Village of Oak Harbor, Ohio
WWTP Improvements
Rebid

ADDENDUM 2

October 22, 2026

SHEET NO.
C-104.2
30 OF 247

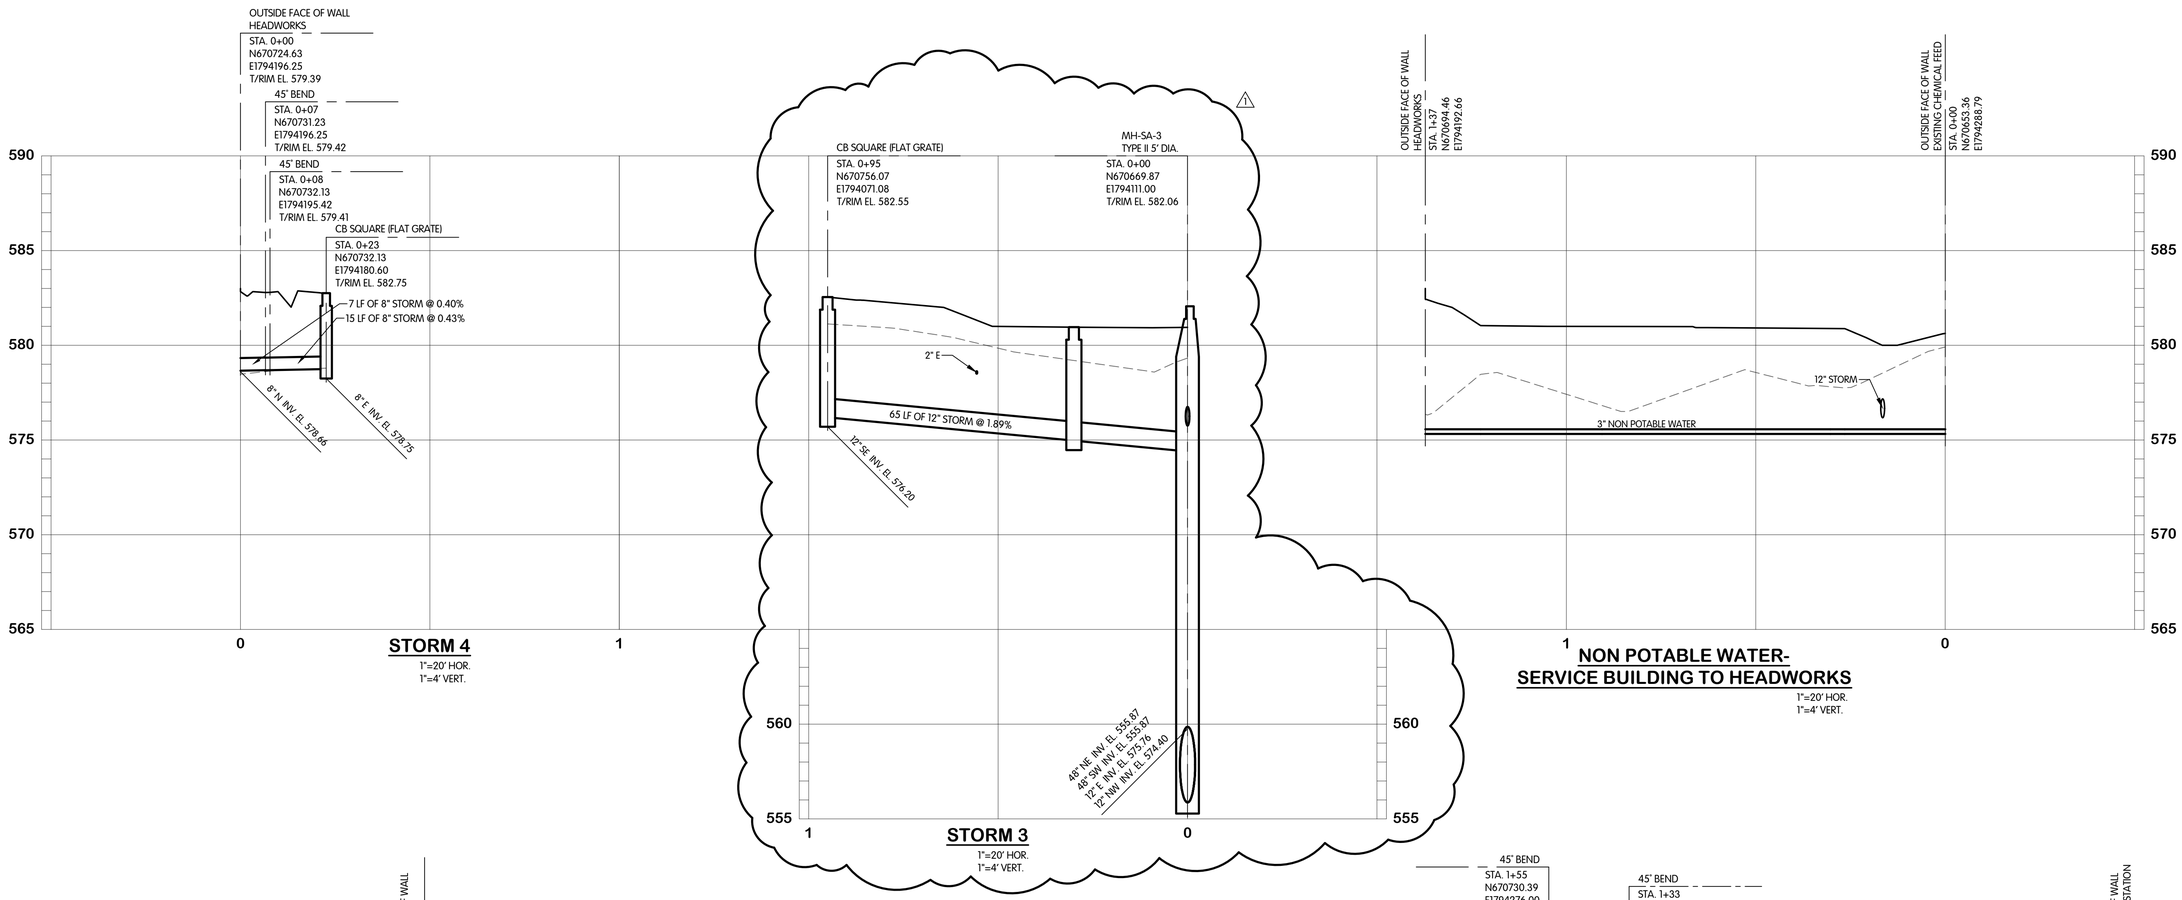
11. The proposed storm from MH-SA-3 to CB ST-2 to CB ST-1 is missing top of casting, invert and or a profile for this storm line. The sheet shown below is C-104.2 (30 of 247)

12. Sheet C 104.2, lower left side, It shows a line coming off an existing 8" water line and maybe a Fire Hydrant symbol. However, the line is in the middle of the access drive.

See addendum 2, Revised Sheet C-104.2

See addendum 2, Revised Sheet C-104.2

SHEET NO.
PE-14.2
156 OF 247

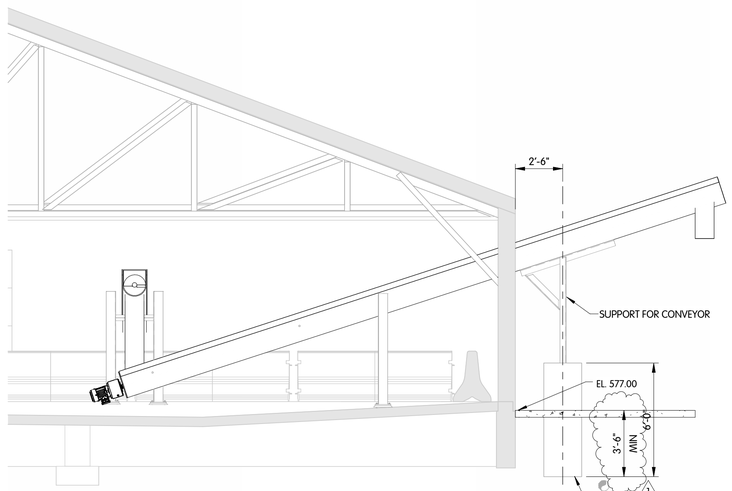
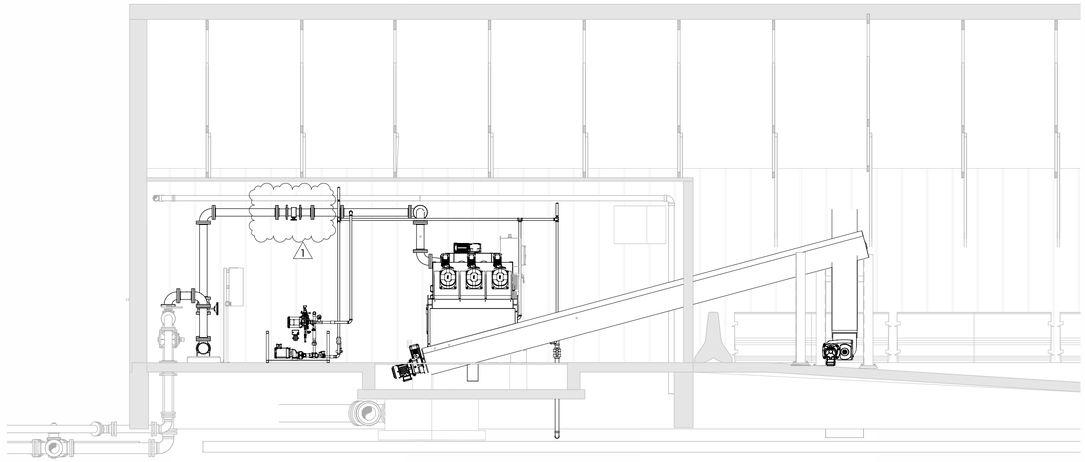
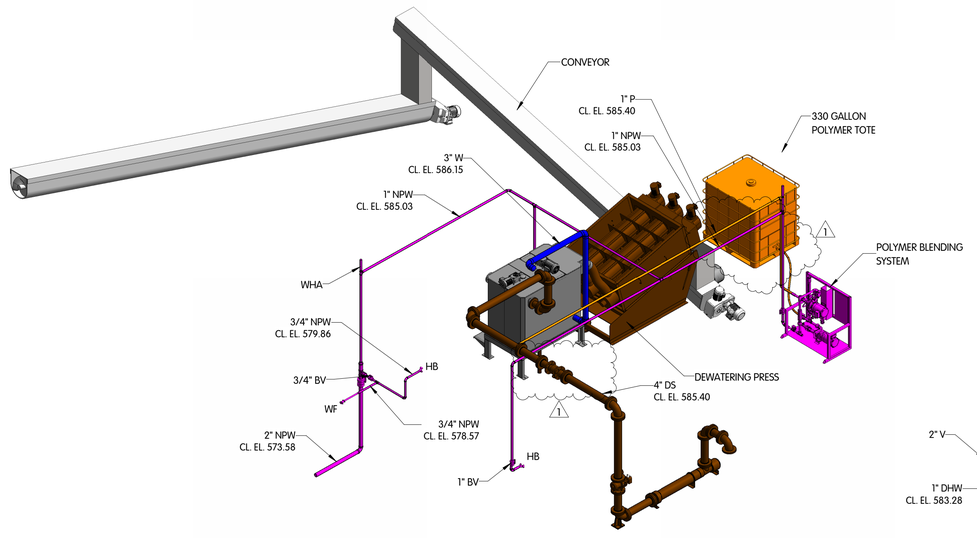
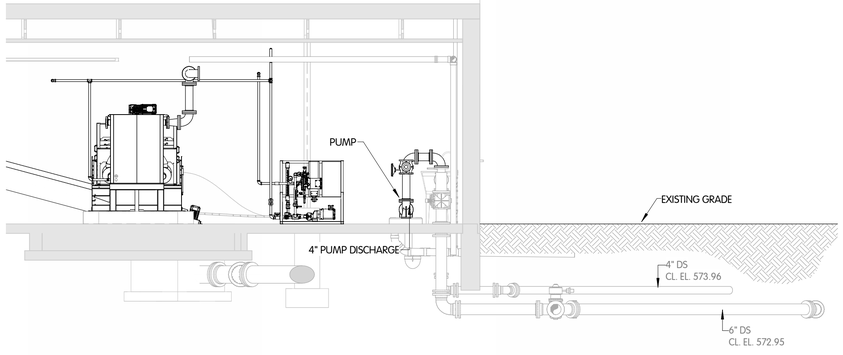
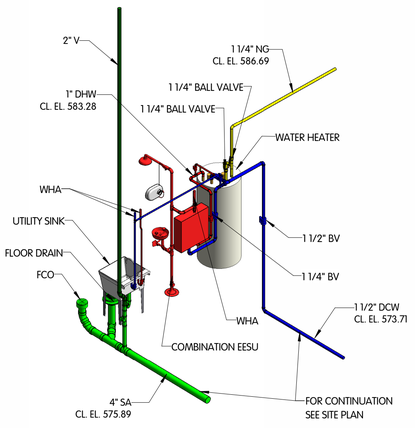
3. The Isometric of the dewatering system show the polymer solution being injected into the sludge line before the sludge flowmeter- this needs to be move to after the flow meter.

See Addendum 2, Revised Sheet PE- 14.2

ELECTRICAL
PLANT SINGLE LINE DIAGRAM AND LOAD SCHEDULES

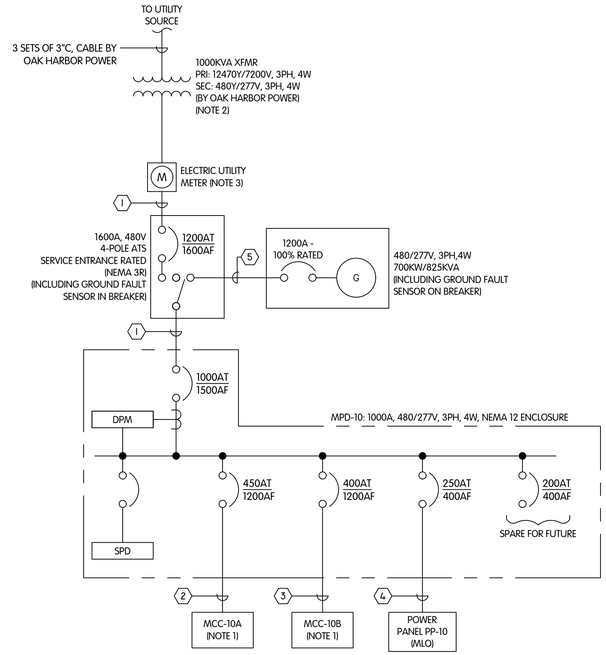
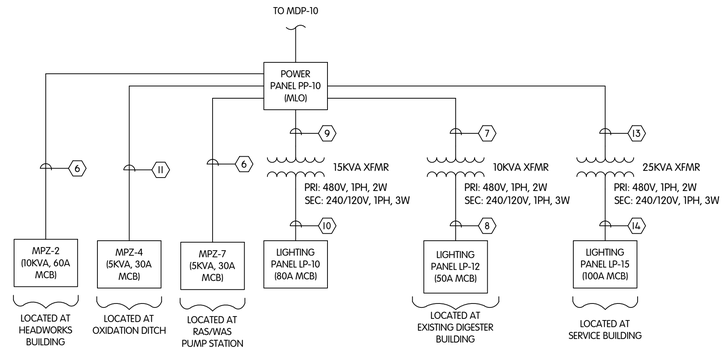
1. Is the Door 200-B, rollup door in the Headworks, motor operated as specified but not shown.

See Addendum 2, Revised Sheets E-0.4, E-101.1, E-2.1, and E-10.3.

HEADWORKS BUILDING
ELECTRICAL
POWER PLAN AT EL. 586.00

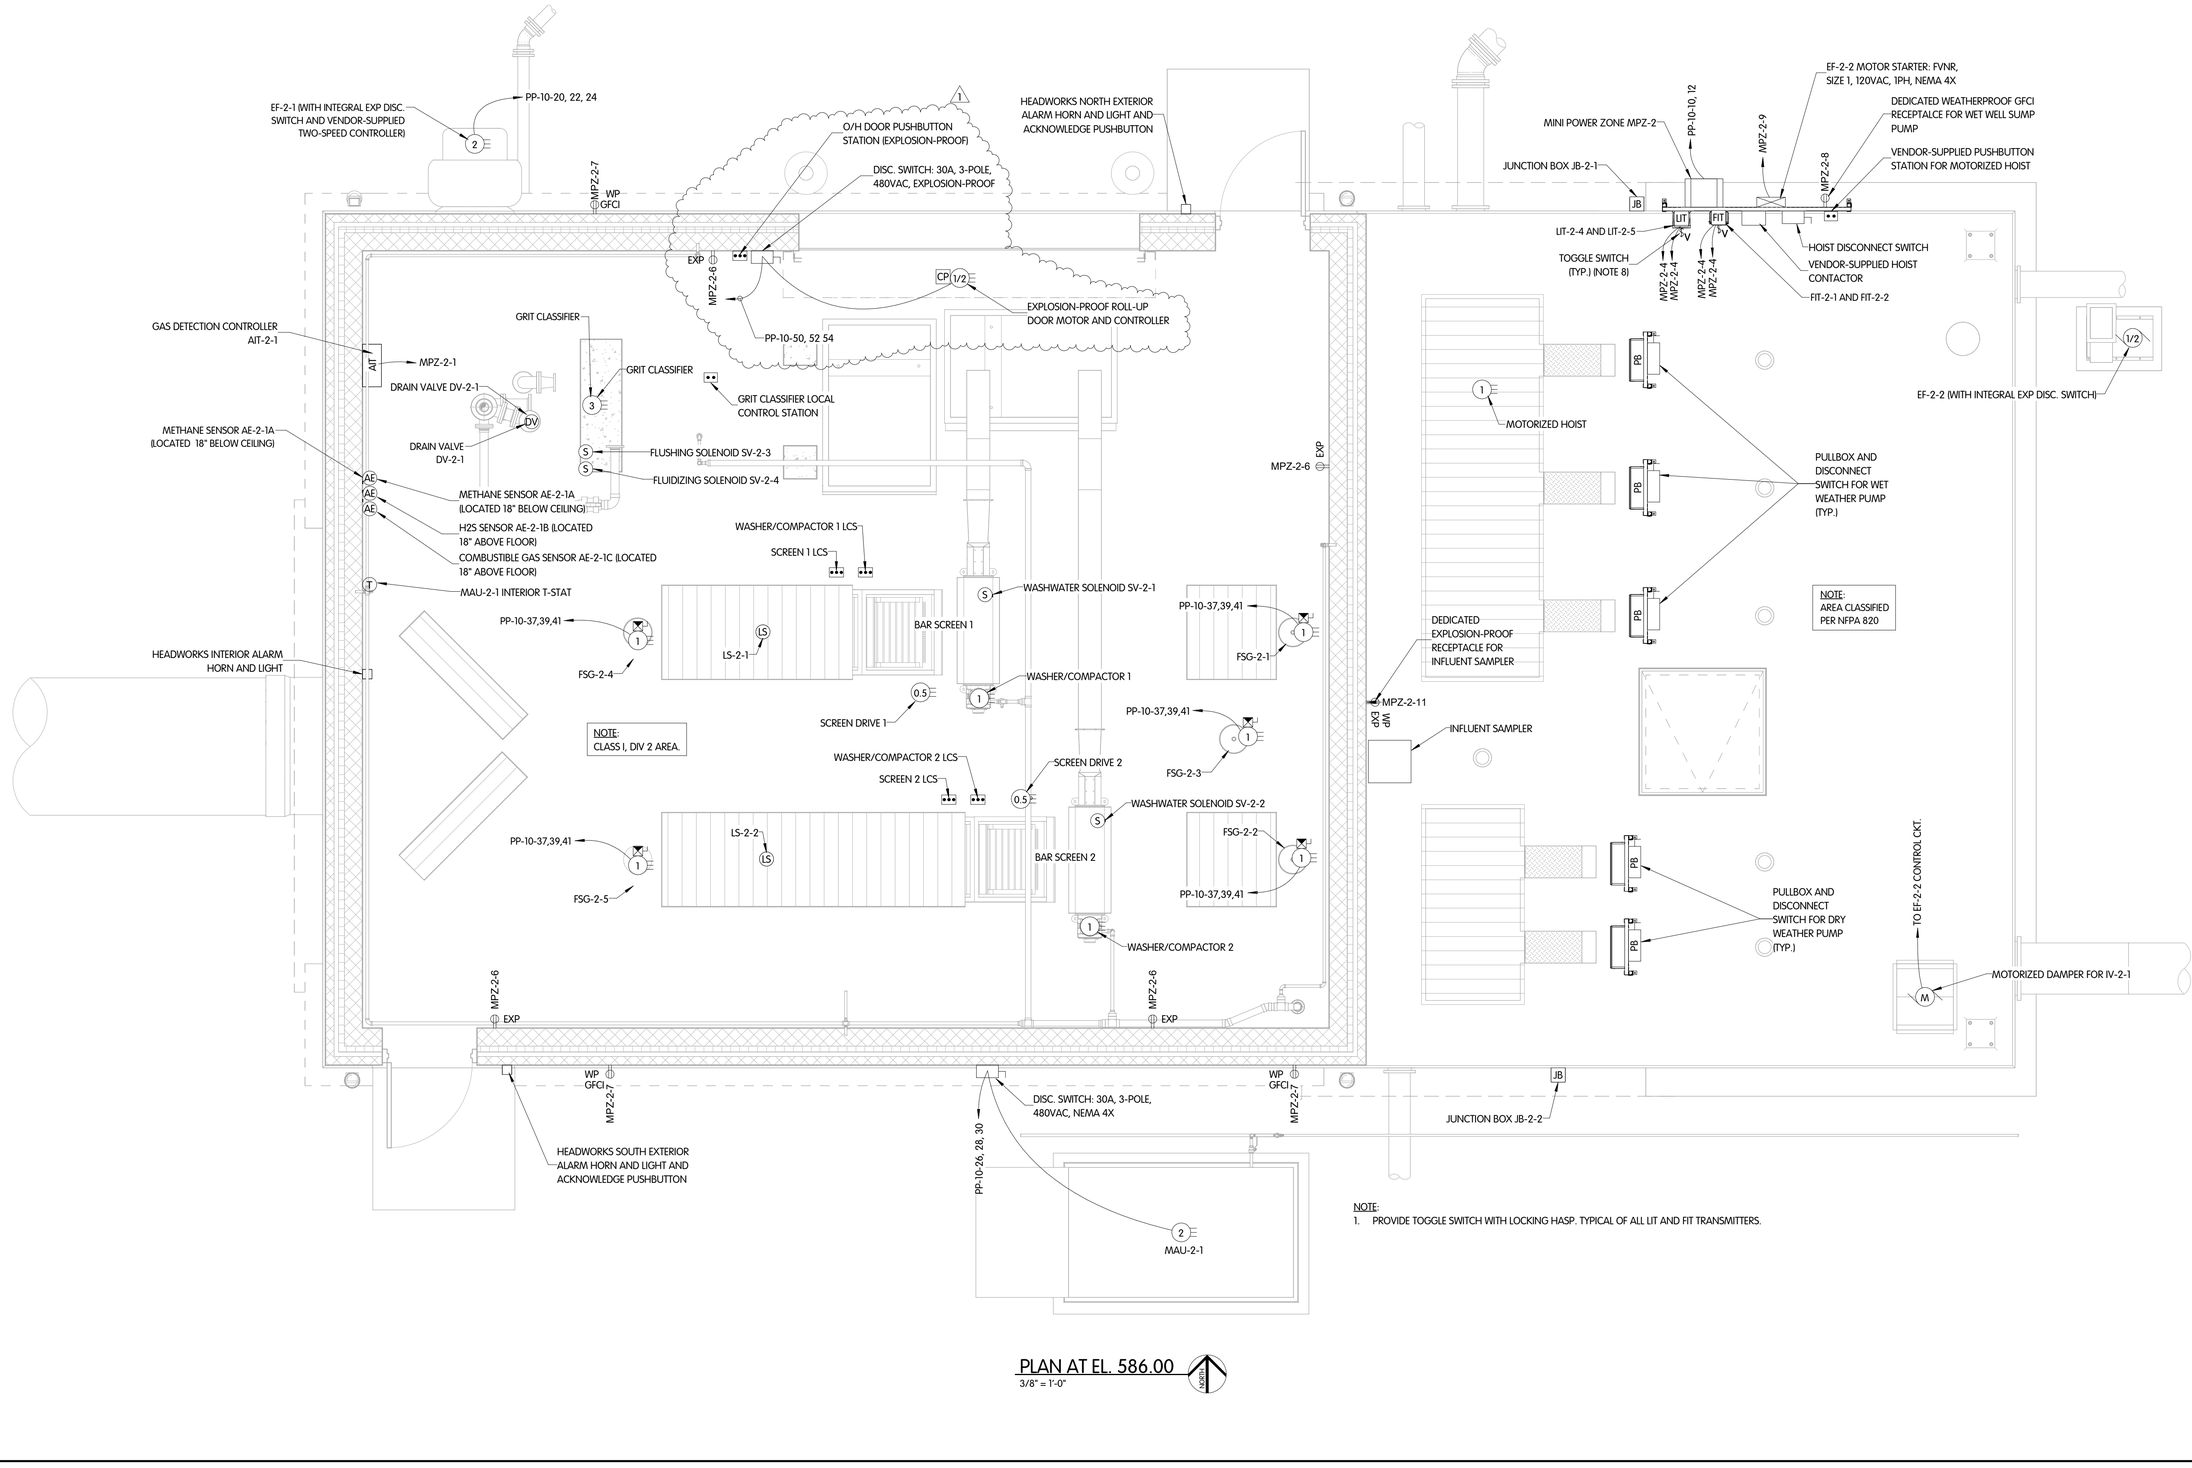
4. The control diagram for the mechanically cleaned bar screen shows one level sensor and one level switch per screen. Sheet E-2.1 only shows one level switch per screen.

See Addendum 2, Revised Sheet E-2.1 with one level switch per screen.
